NATIONAL OILWELL VARCO

PRODUCT INFORMATION BULLETIN

NUMBER: 06-02-01-ST

PRODUCT: Turnback Roller / Winchline Deflector Assembly #5281A010

SUBJECT: WEARPLATE
PART NUMBER 80-710-023

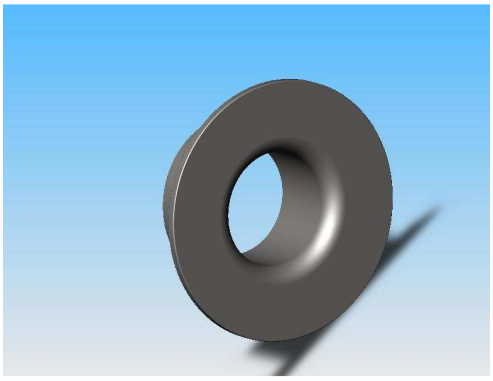
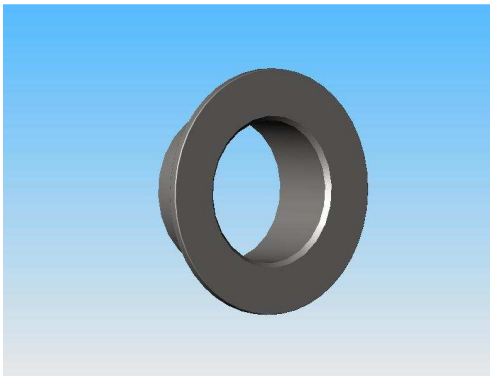
The wearplate has been revised to provide better flow through the bore by reducing the flow resistance.

Originally, the bore was 76.200 millimeters, (3.000 inches). The revised wearplate has a bore of 101.6 millimeters, (4.0 inches). In addition, the entrance radius has been changed to a chamfered entrance of 3.2 millimeters x 45 degrees, (1/8 inches x 45 degrees). The exit end of the bore is chamfered similarly.

The new wearplate is revision D. Part number remains the same as before, 80-710-023.

<u>Only wearplates with the larger diameter bore should be used in the Hex 240 drilling pump.</u>

SUBJECT: PISTON RODS
80-710-023 (ONCE PIECE)
80-710-024 & 80-710-047 (TWO PIECE ROD SET)

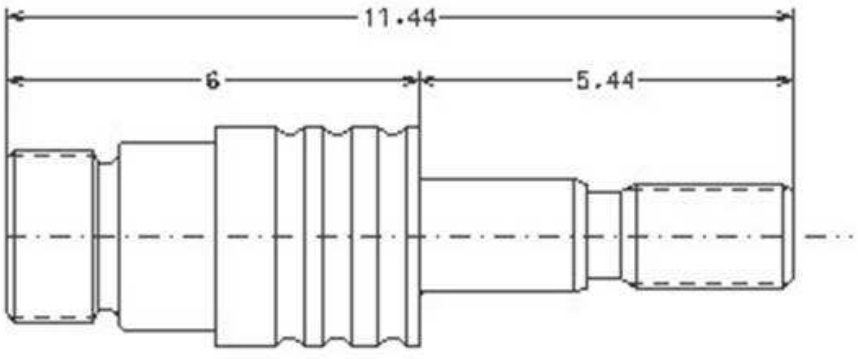
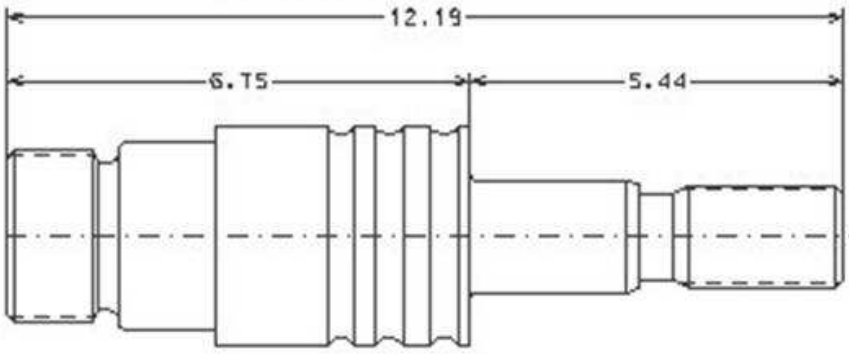
The piston rods for the Hex 240 drilling pump have been changed to prevent the possibility of stroking too close to the bottom of the liner.

The part number remains the same. Only the revision was changed. The latest revision is "C" for the one-piece rod, 80-710-070. Previous configurations of the rod are shown for revisions A and B. See the following pages for the progression of changes to the rod.

Early production of the Hex pump used a two-piece rod. The short piston rod was threaded into a sub-rod to make the assembly. Only the short piston rod (80-710-024) was affected by the changes in length. The sub-rod (80-710-047) was not changed. The combined length of the sub-rod and short piston rod are the same length as the one-piece rod, 80-710-070. See the following pages for the progression of changes to the rod.

The latest revision for the short piston rod is revision "F".

Only piston rod 80-710-070 rev C, or the short piston rod, 80-710-024 rev F, should be used in the Hex 240 pump.

Use of the previous rods can cause excessive mud bypass across the piston.

ILLUSTRATION 1

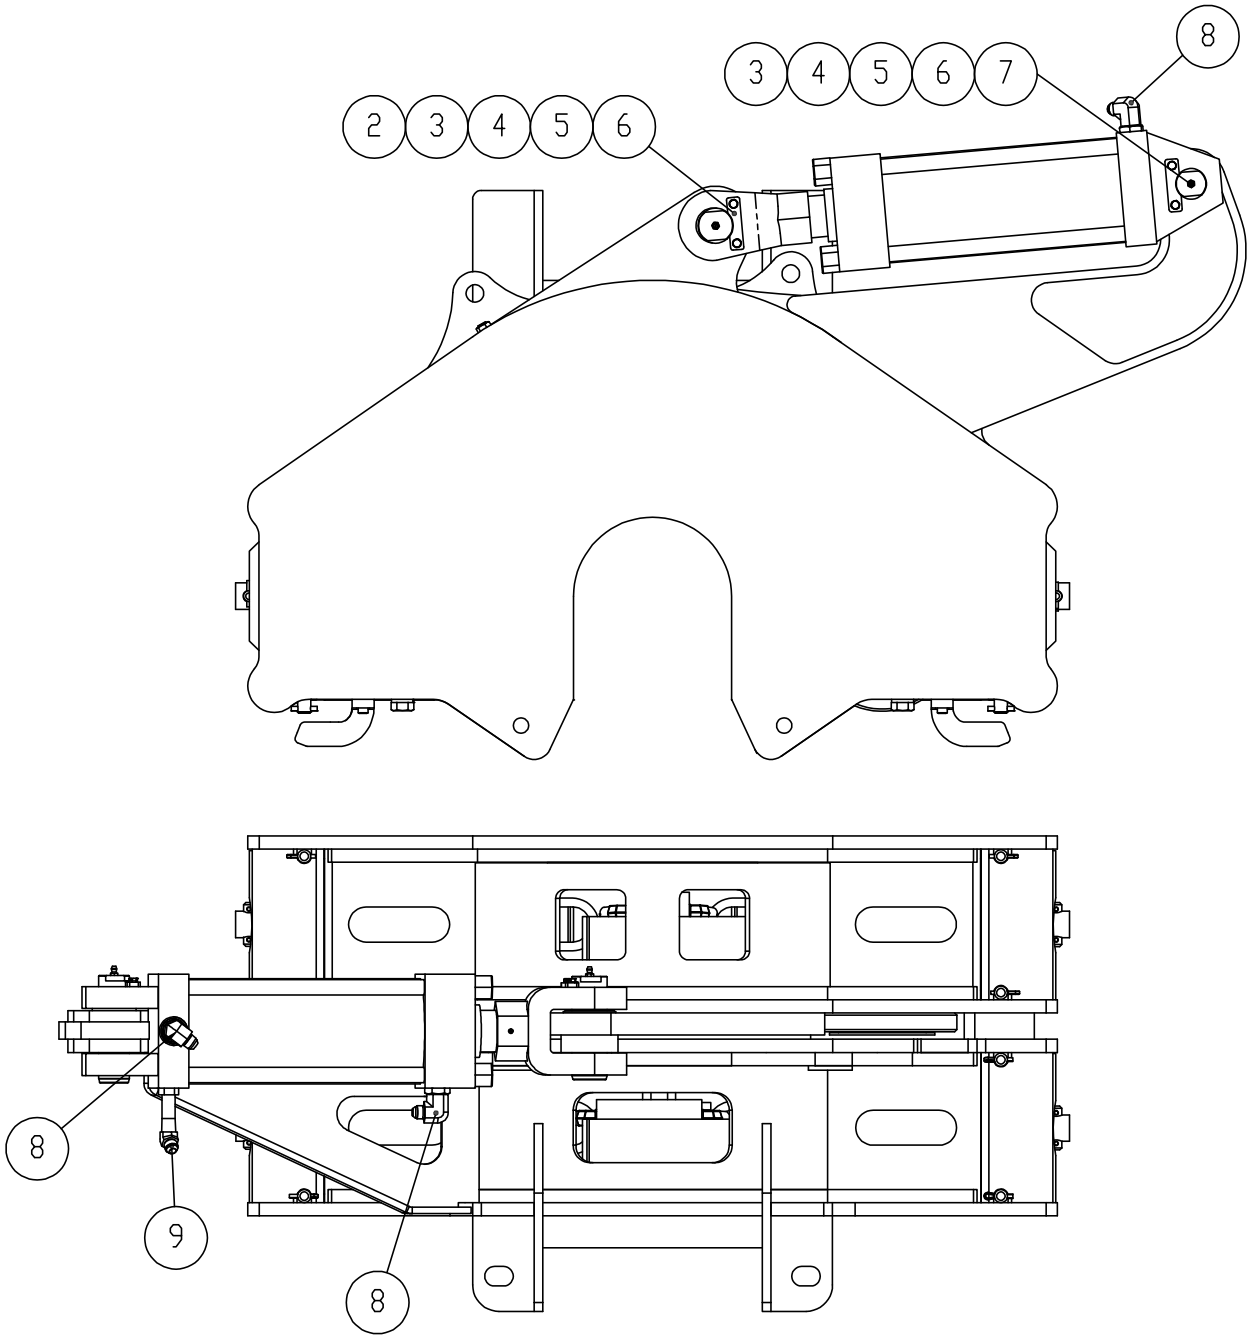
There have been reports that the existing externally mounted limit switch may become contaminated, thus not allowing the plunger on the limit switch to return to its neutral position, which in turn gives a false indication on the Remote Control Console that another makeup repeat must be made.

A new Torque Cylinder Assembly is available which consists of a built in limit switch. This switch sends a signal to the Remote Control Console when the cylinder has reached its fully retracted position. This limit switch is built in internally to the cylinder, which eliminates the possibility of contamination.

For the installation of the new torque cylinder assembly, remove the entire old torque cylinder assembly including the pins. Disconnect the wires from the old limit switch at the junction box mounted on the hydraulic enclosure and pull the cable out of the blue hose. Next, install the new torque cylinder assembly as shown in illustration 1. Route the wires from the new limit switch through the blue hose to the junction box mounted on the hydraulic enclosure. Please see illustration 2 for wiring information.

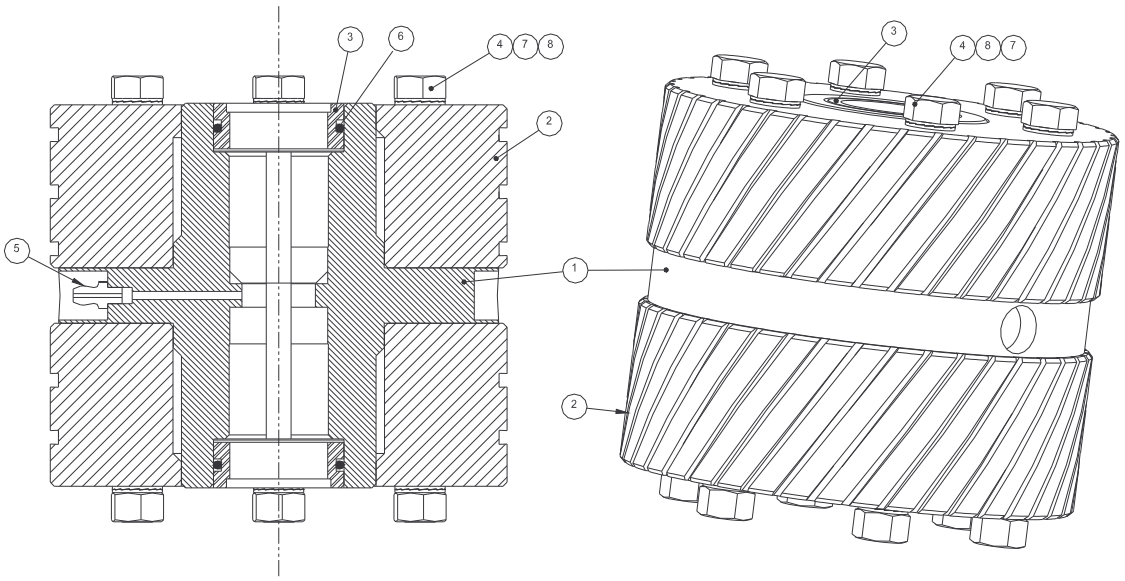
4.1.1. The spinner grip cylinder has been equipped with a counterbalance valve. This is plumbed so that the spinner itself will not require any changes to the design of the hydraulic system. The counterbalance valve is there to assist in keeping a good grip on the pipe even if the pipe surface is uneven or out-of-round. Also, the rod clevis has been made a separate part with its own part number.

4.1.2. The spinner roller assembly change includes a new hub (or body) as well as the rollers and seal spacer. The roller body has been slotted to accept the double-key arrangement on the newer motors and the roller. The assembly can be ordered as a whole (see below P/N SP02-05) or the parts can be ordered separately. The assembly is interchangeable (as a whole) but the individual parts are not compatible with the old design.

4.1.3. The spinner catch arm was strengthened in the area that is affected when initial contact with the pipe is uneven. This arm is interchangeable for all IR170 units.

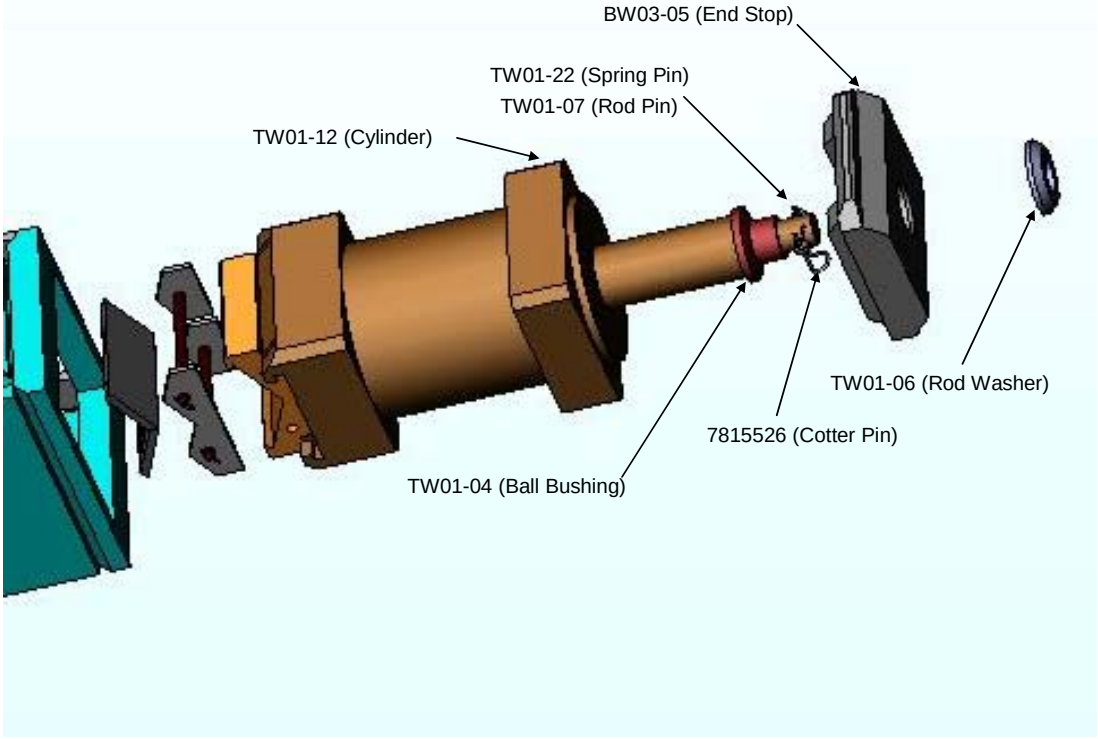
4.1.1. Torque Wrench Clamp Cylinder: Has been changed to welded-body construction. Tie rod type cylinders should no longer be used. This change affects all IR170 units with 5ksi cylinder operating pressure (and no third party certifications).

This image below illustrates a typical assembly for cylinder installation.
Assembly Note: Apply grease to the mating surfaces Ball Bushing (TW01-04) and End Stop (BW03-05).

Illustration 1

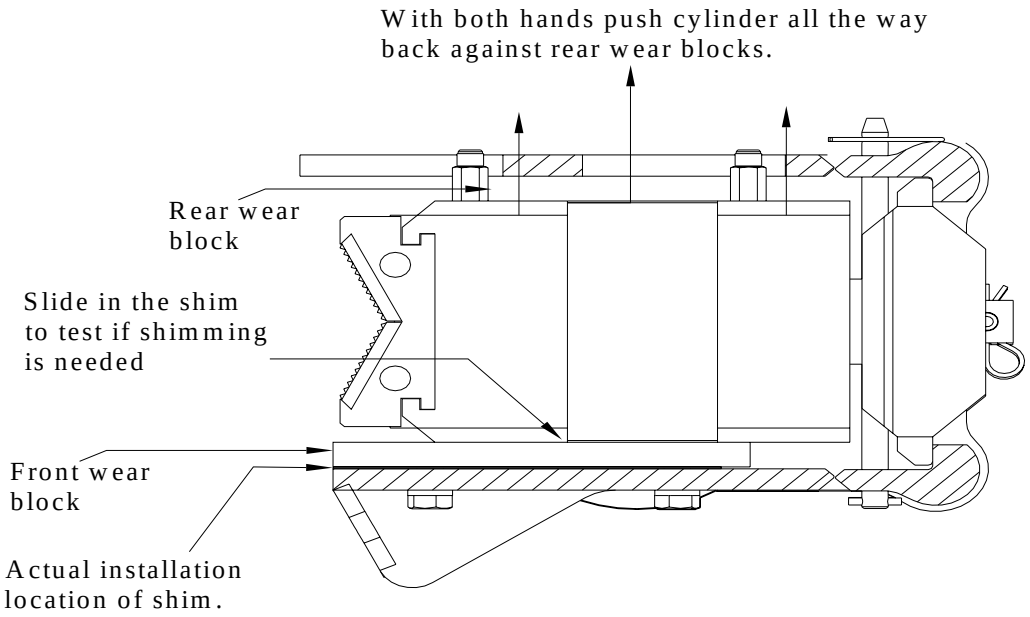
5. Install the cylinder without installing the cylinder back plate. Using both hands, push the cylinder all the way back up against the back of the wrench housing and check for any gap (see Illustration 1). If a shim can slide between the cylinder and the front wear block, remove the wear block and install the shim. More than one shim may be needed.

To get the fullest life span of the jaw cylinders and the dies, the IR3080/IR30120 jaw cylinders must be checked for proper gap for normal operation. If more than 1/16" gap is observed, the cylinders must be shimmed. Shims must be added as necessary and may not be needed on every wear block, from top to bottom and left to right (see illustration 2 below). This depends on manufacturing tolerances from mating parts, as well as how the parts wear during normal operation. Shims may also need to be added when worn jaw cylinders have been replaced.

Figure 1: Low drum drive shifter - spring disengaged (not fail-safe)

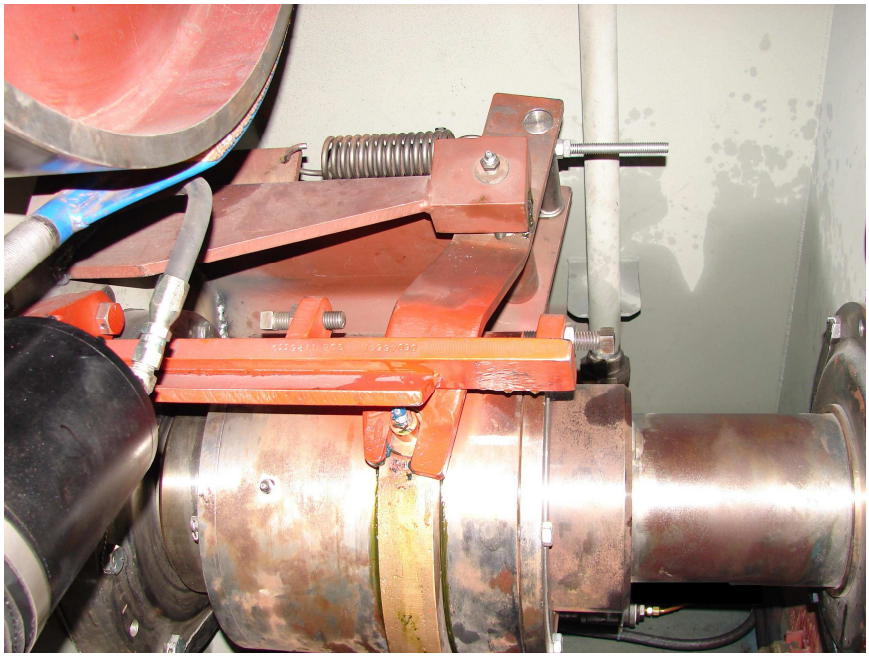
Verify that the low drum drive shifter is installed in spring-engaged (fail-safe) mode while in low gear. When the low drum drive is engaged, check the shifter pneumatic cylinder for air pressure. If the cylinder is not pressurized, then the low drum drive is spring engaged and nothing more is required. However, if the pneumatic cylinder is pressurized, then the shifter assembly is spring disengaged as shown in *figure 1* and needs to be reconfigured for fail-safe operation.

Figure 2: CAD illustration with shifter bracket dimension and sleeve orientation

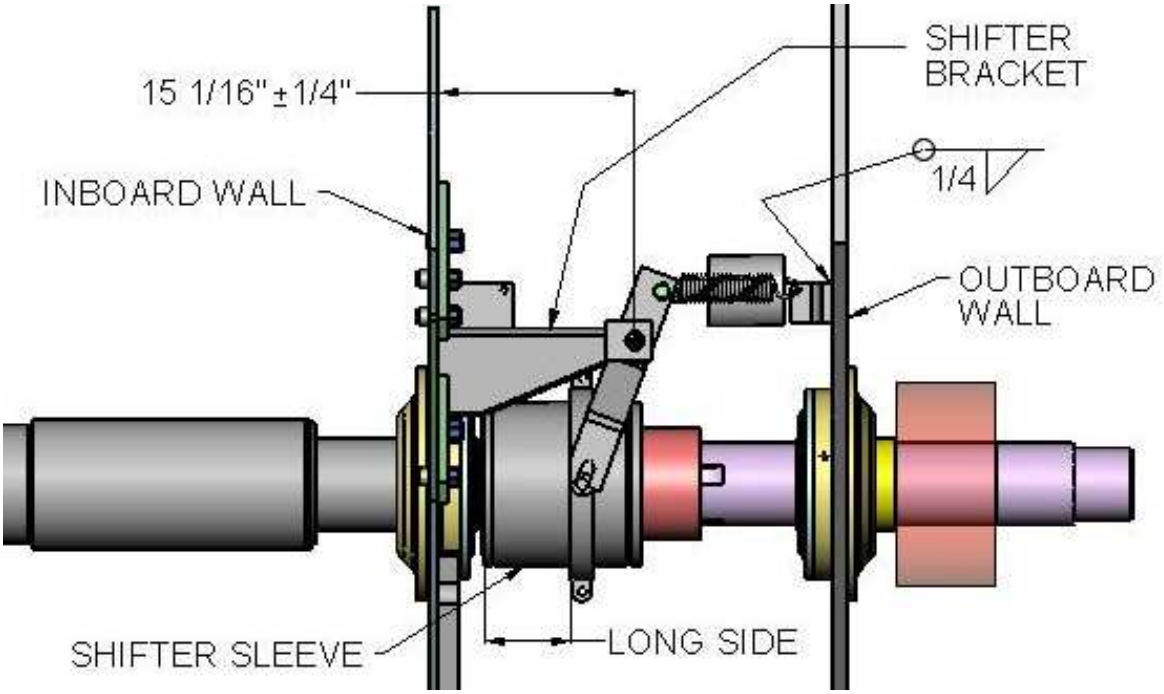
Referring to *figure 2*, verify that the distance from the inboard wall to the pivot point of the shifter bracket is 15 $^{1}/_{16}$" +/- $^{1}/_{4}$" and the shifter sleeve is oriented with the long side toward the inboard wall. If the shifter bracket dimension and/or sleeve orientation differ from *figure 2*, contact National Oilwell Varco Service and Repair for assistance before attempting to reconfigure the shifter assembly.

Figure 3: Shifter fork bevel dimensions

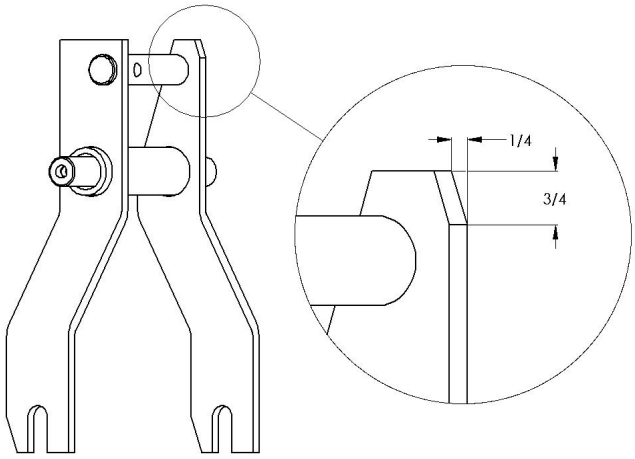
To make the low drum drive shifter spring engaged, the cylinder and spring must be attached to the outboard wall with a mounting kit, P/N 656934, available from National Oilwell Varco. Note that the corner of the shifter fork needs to be beveled as shown in *figure 3* to provide clearance for the cylinder clevis.

Figure 4: Low drum drive shifter - spring engaged (fail-safe)

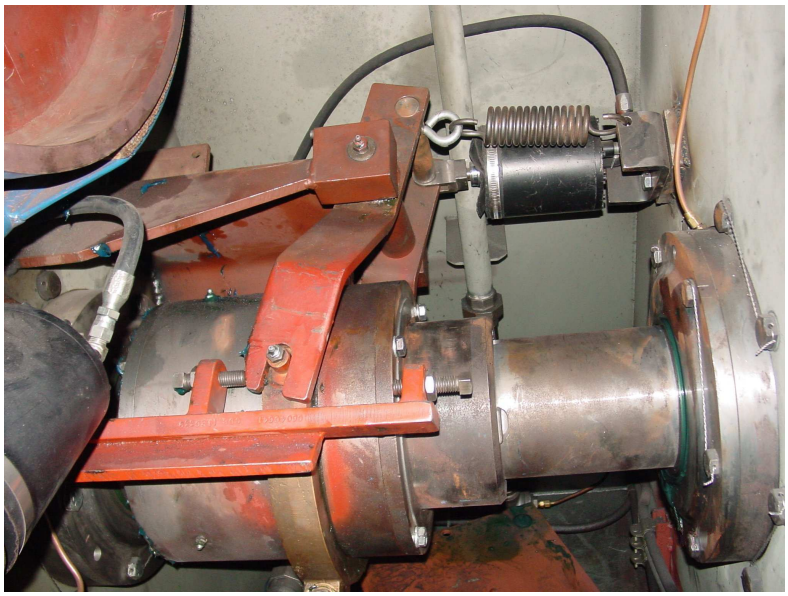
Align the cylinder and spring such that they are perpendicular to the outboard wall using the bracket and tap pad provided with the mounting kit. Once located, weld ($^{1}/_{4}$" fillet all around) the tap pad as shown in *figure 2*. Bolt the mounting bracket to the tap pad and attach the cylinder and spring to the mounting bracket. Verify that the spring engages the drive and the cylinder disengages the drive. Refer to *figure 4* for the low drum drive shifter assembly after reconfiguration.

NOTE: When correctly configured, the low drum drive shifter will be disengaged with air applied to the pneumatic cylinder and engaged when air is **not** applied to the cylinder. The valve at the driller's control panel will operate accordingly.

Figure 5: Standard E-3000 and M-3000 valve lettering (TOP) and new name panel label (BOTTOM)

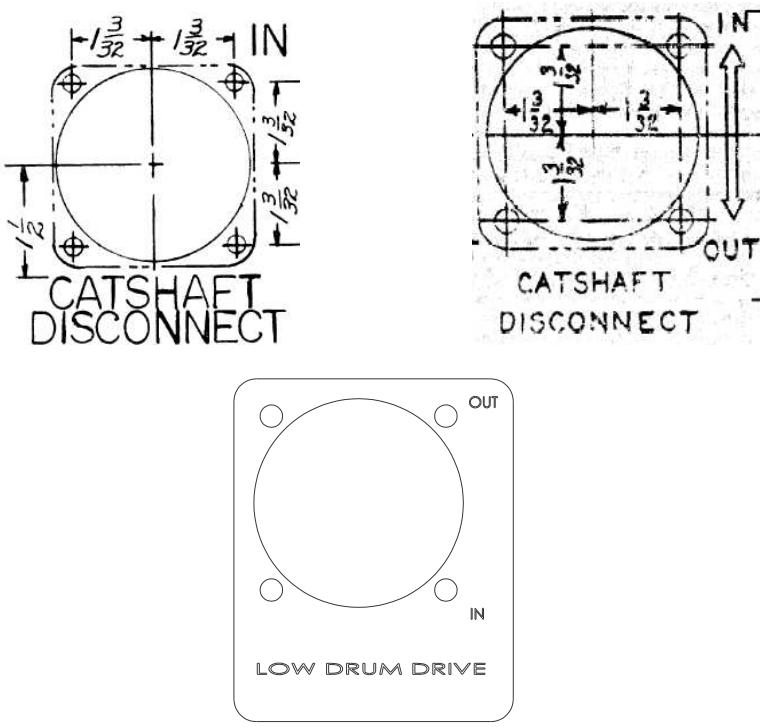
Install the name plate included in the mounting kit, P/N 656934, onto standard E-3000 & M-3000 drawworks control panels. Grind off existing lettering for the low drum drive shifter valve and install name plate between valve and control panel using the existing screws, nuts, and washers. Standard control panel lettering and new name plate shown in *figure 5*.
